MEMORANDUM

Re: Planned Development and Design Review Modification & Time Extension Request
for District North at approximately 523 W 200 N

Request for Design Review Modifications

200 North Elevation

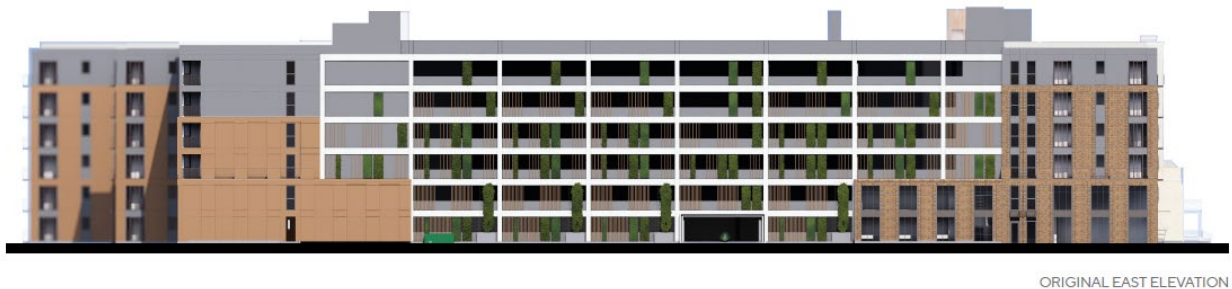
- Material changed from plaster (non-durable) and brick to paneling (tiles/fiber cement board) on the upper two levels of the north facing façade.
- Private balconies on levels 3-6 the northeast corner were removed due to changes in the floorplan and increase in residential amenities.
- Townhomes (outlined in orange) were widened to allow for larger 3-bedroom units. They remain in the same location but were reduced from 9 to 6 units. While this is a noted change, it is not part of the requested Design Review modifications.

500 West Elevation

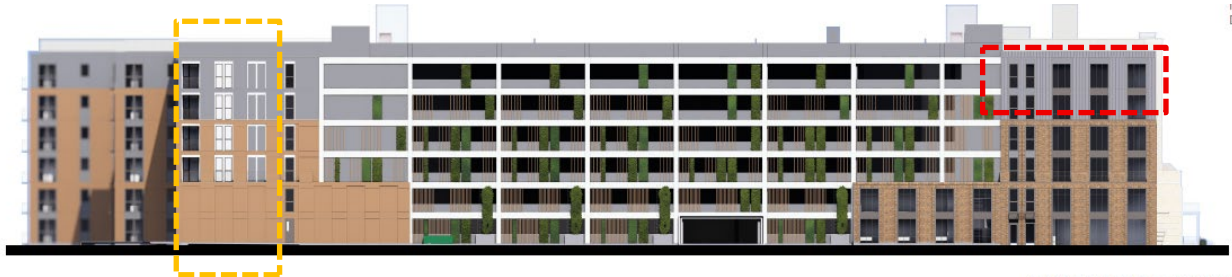
- Material changed from plaster (non-durable) and brick to paneling (tiles/fiber cement board) on the upper two levels of the east facing façade.
- Private balconies on floor 3-6 of the northeast corner were removed due to changes in the floorplan and increase in residential amenities.
- Windows and balconies were added to the residential units on the southern portion of the façade (outlined in orange), which is the result of changing the interior floorplan.

PROPOSED ELEVATION - NORTH

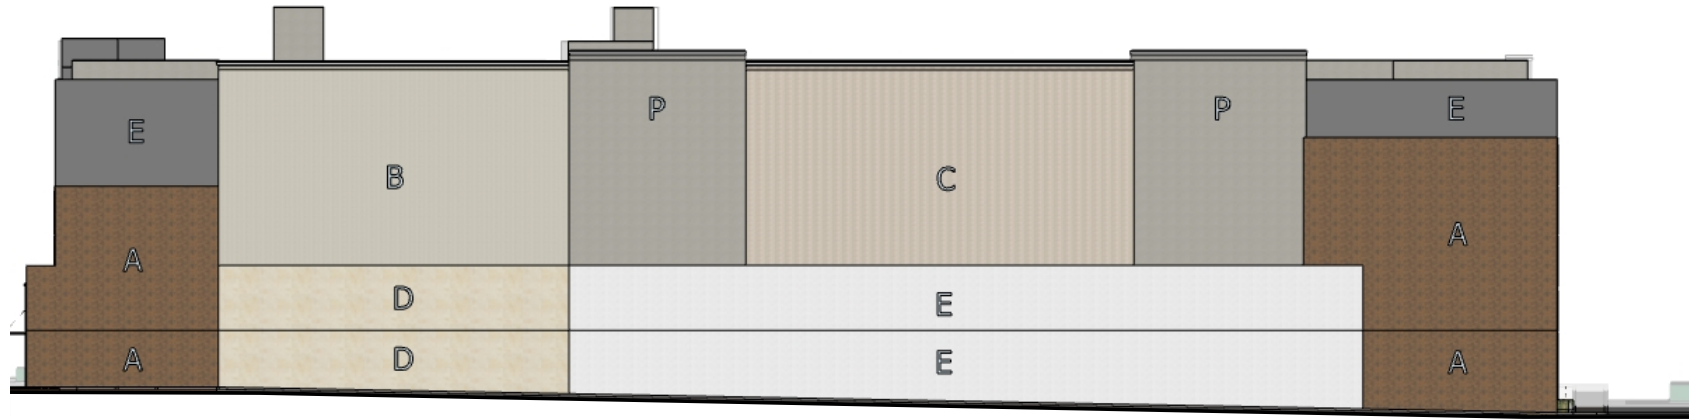
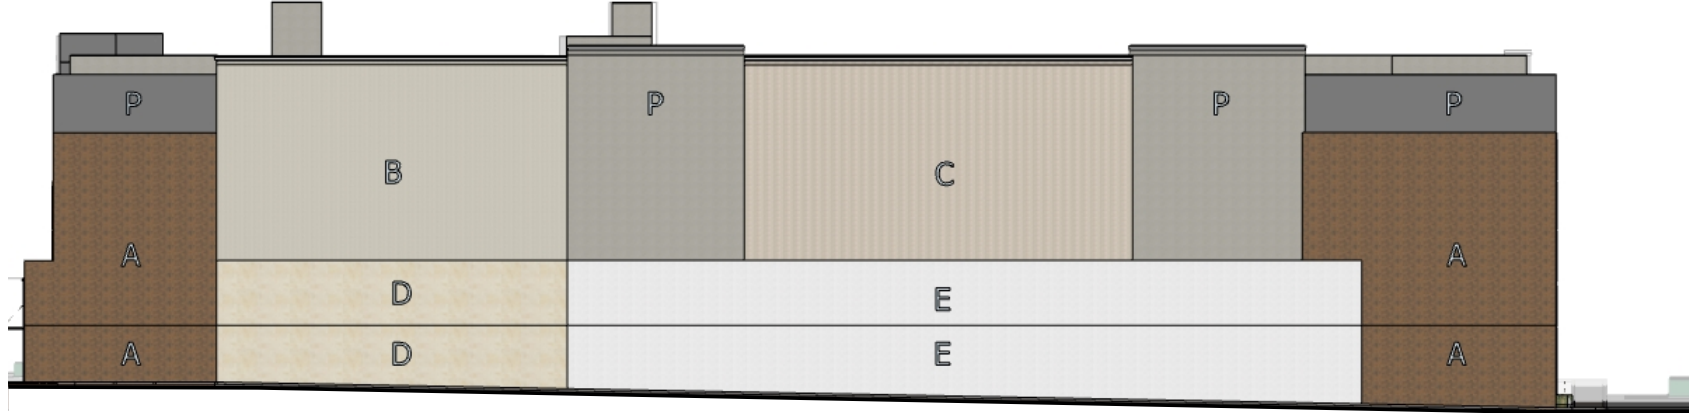
The applicant is proposing to change the building materials on the upper two levels of the northeast corner from plaster/EIFS (a non-durable material) and brick to paneling consisting of fiber cement board and to remove the private balconies at the same location. The reduction in plaster/EIFS resulted in slight changes to the durable material percentages that do not require Planning Commission approval (see building elevations in Attachment B). The percentage of plaster/EIFS on the 200 North façade would decrease from 24.3% to 18.2% and from 19.7% to 16.2% on the 500 West façade. The proposed material changes comply with the current MU-6 zoning requirements, which require that at least 70% of materials on both upper and lower levels be durable.

Under the former TSA zoning, plaster/EIFS was limited to 10% of upper-level facades. While the proposed design would still exceed that limit, it aligns with the updated and simplified MU-6 zoning standards by meeting the 70% durable material requirement on both the upper and lower levels.
